ADDENDUM No. 1

REQUEST FOR QUOTATIONS No.:	1220-040-2023-043
TITLE:	RCMP Main Headquarters Cooling Tower Replacement
ADDENDUM ISSUE DATE:	August 2 nd , 2023
REVISED CLOSING DATE AND TIME:	The City would prefer to receive Quotations on or before August 14 th , 2023.

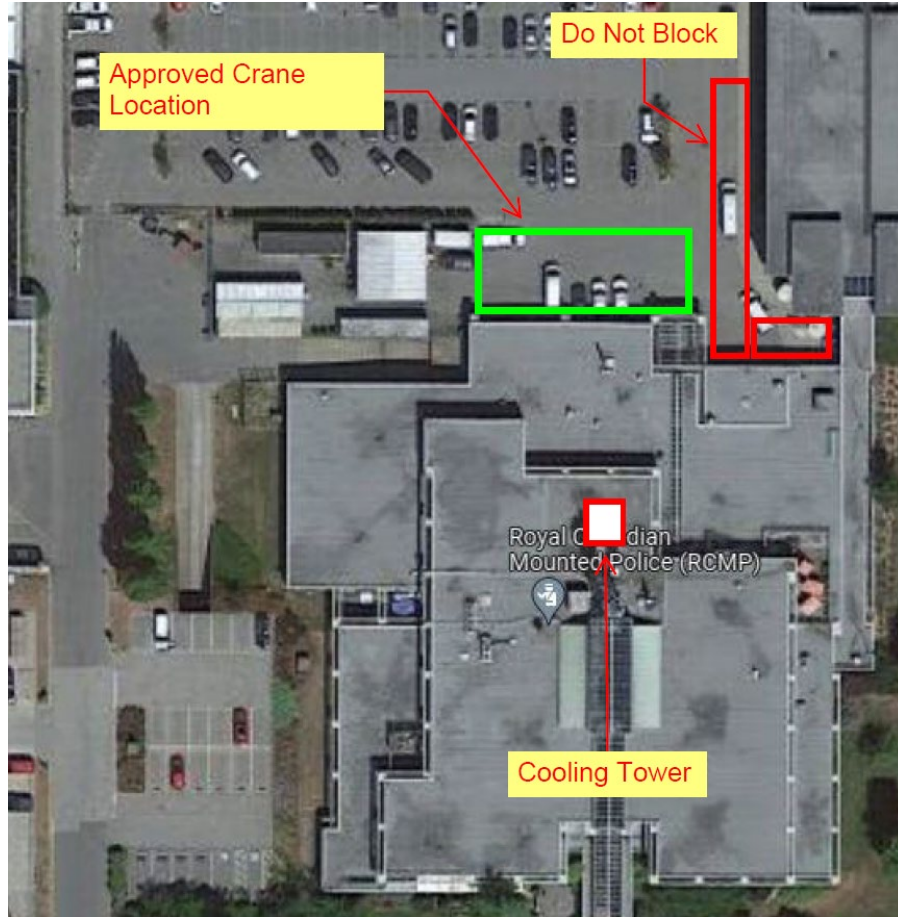
Q2. Please provide crane access locations

A2. Crane to be set up from the north parking lot with notice. See map below.
